Arapahoe County Public Works & Development Engineering Services Division Staff Report Planning Commission

Re: Arapahoe Retail 7-ELEVEN

ASP25-003

PM25-001

Proposed Alternative 3: Provide Underground Detention and Underwater Quality for the proposed site.

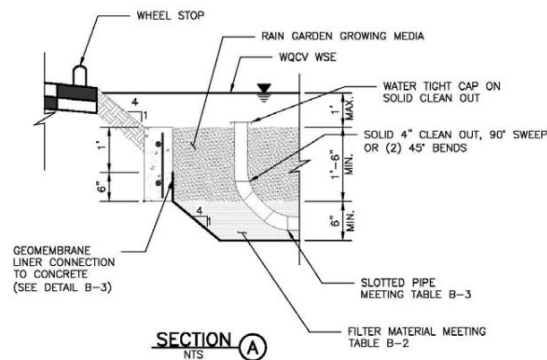
K2 investigated the ability to utilize an ADS Underground Detention Facility to provide an underground detention facility and provide water quality treatment using an isolator row.

The proposed underground detention could be set directly at the invert of the proposed stormwater pipe (5436.00) with a discharging elevation of approximately 5435.5'. This design would remove any stormwater backup into the proposed system, as the stormwater would fill in the volume of the stormwater from approximately 5435.5 to 5437.83. K2 and 7-Eleven have developed multiple sites that utilize this underground detention system, and it would eliminate any stormwater backup into the proposed site.

In previous variance requests to Arapahoe County and TRC, this underground detention variance has been denied.

Proposed Alternative 4: Eliminate inlet drops, utilize MHFD rain garden reduction in media, and reduce pipe sizes to raise invert into the pond.

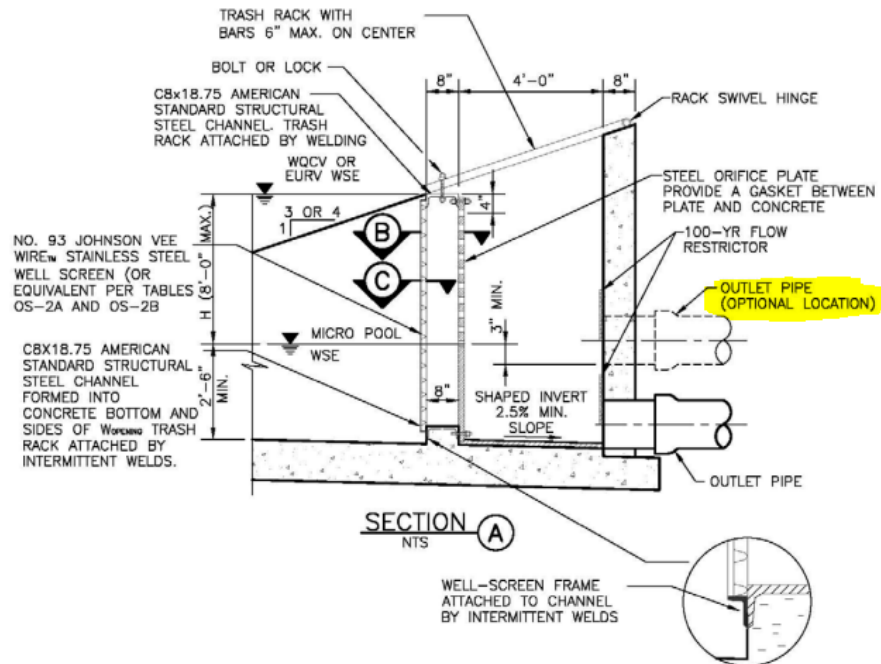
In order to gain additional height within the proposed rain garden, two variances could be applied on-site; one to remove the 0.1' drop within the proposed storm structures and one utilizing the MHFD rain garden detail. The proposed detail shown below only requires an 18" cross section and allows for a 0.5% slope within the 4" underdrain. These raised the bottom of the pond elevation to 5433.98'. This would still result in back up into the proposed system (100-yr HGL at 5434.39').
